AS-Rev pathTrace issue

11 March 2019

Mitsubishi Electric

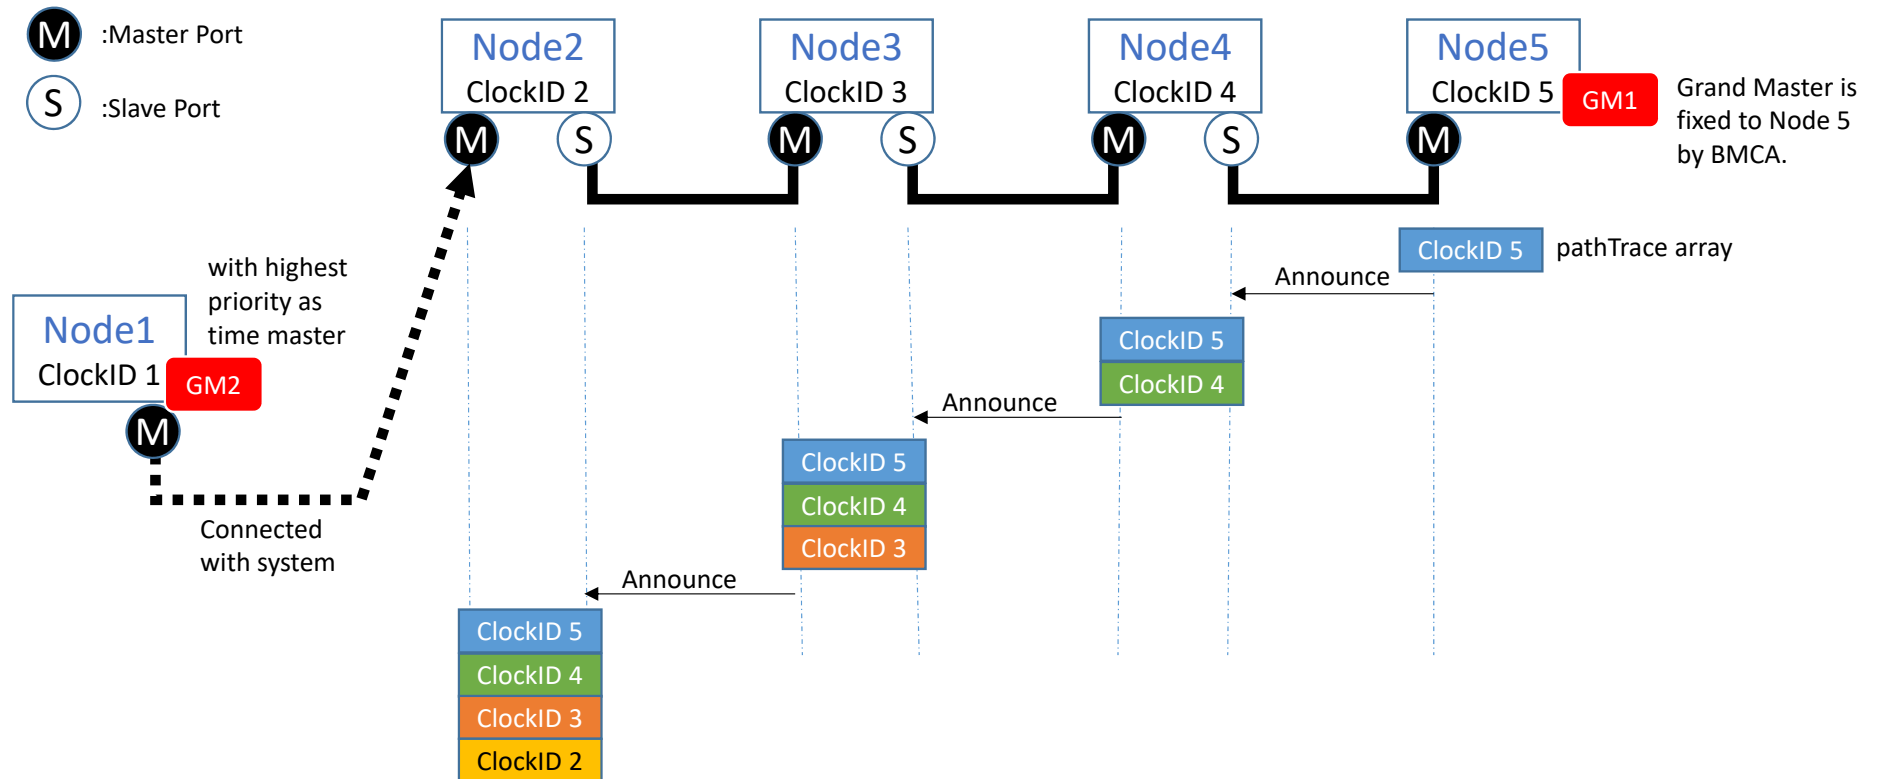
Node 5 has the highest priority of time master, and becomes the grand master in the system. All nodes update their pathTrace information array according to the Announce message.

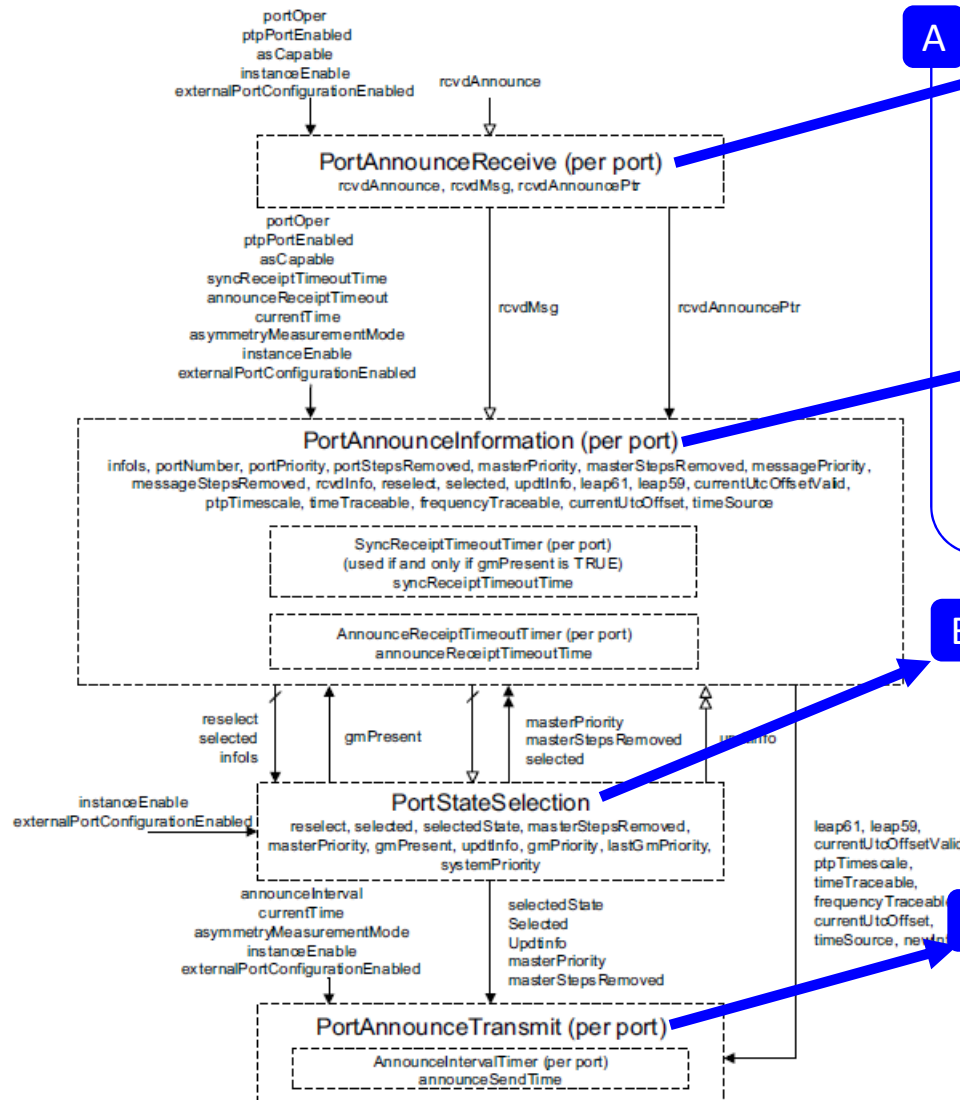
Specification status in D8.0

A After received Announce, the qualifyAnnounce (rcvdAnnouncePtr) is called in the “10.3.11. PortAnnounceReceive state machine”.

d) ... If a path trace TLV is present and the portState is SlavePort, the pathSequence array field of the TLV is copied to the global array pathTrace, and thisClock is appended to pathTrace (i.e., is added to the end of the array). ,then the rcvdMsg becomes TRUE.

Figure 10-11—Best master clock selection state machines—overview and interrelationships

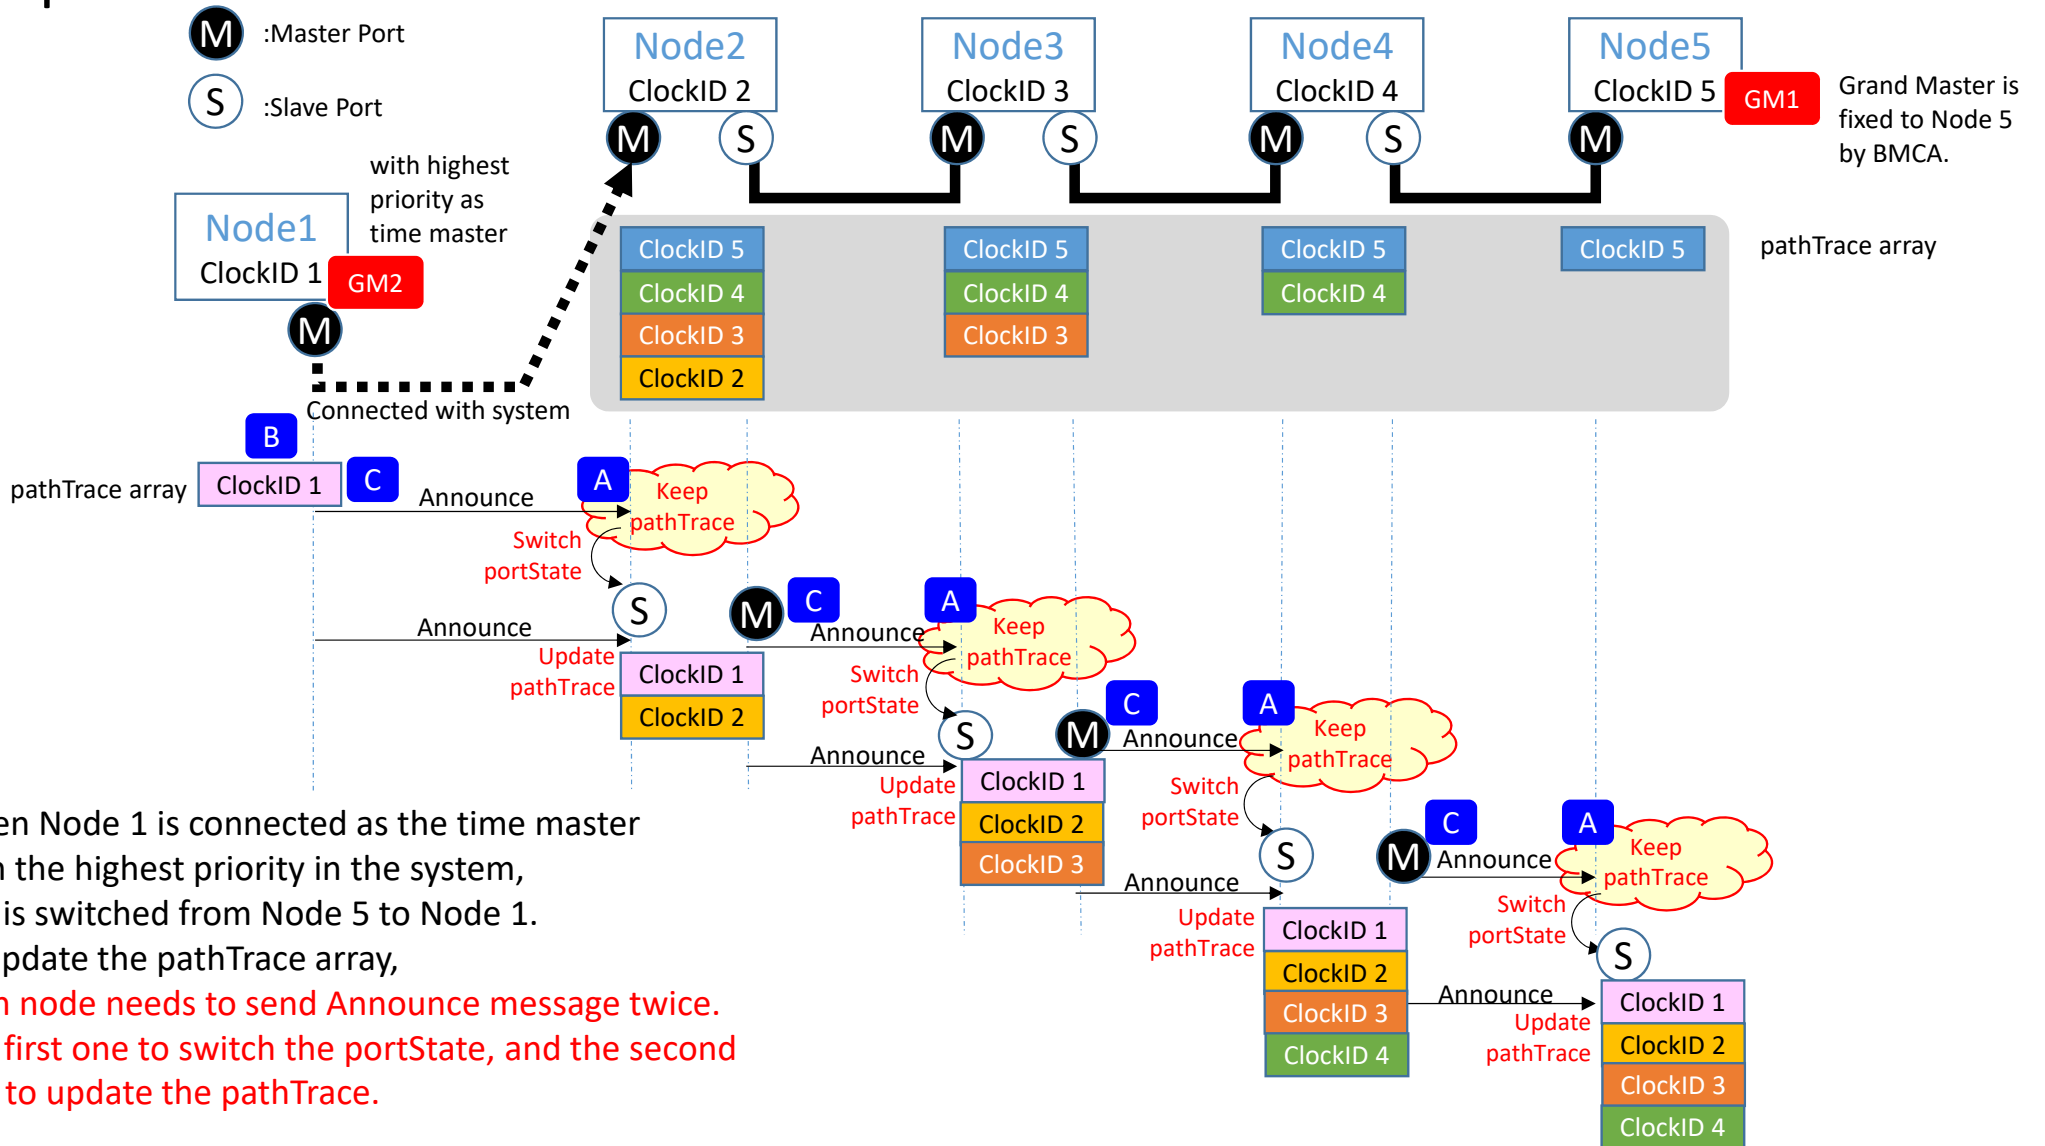
B When the rcvdMsg is TRUE, the rcvInfo() is called in the “10.3.12 PortAnnounce Information state machine”.

When the received Announce has the highest priority, the reselect becomes TRUE and the rcvdMsg becomes FALSE. And the pathSequence field in the received Announce is NOT copied into the pathTrace array because the rcvdMsg becomes FALSE before the portState is decided to SlavePort.

C After detected the GM with the highest priority, the reselect becomes TRUE, and the portState is decided in the “10.3.13 PortStateSelection state machine”.

C After the portState is decided to MasterPort, Announce is sent from it.

The value of pathTrace array is copied into the pathSequence of the Announce.
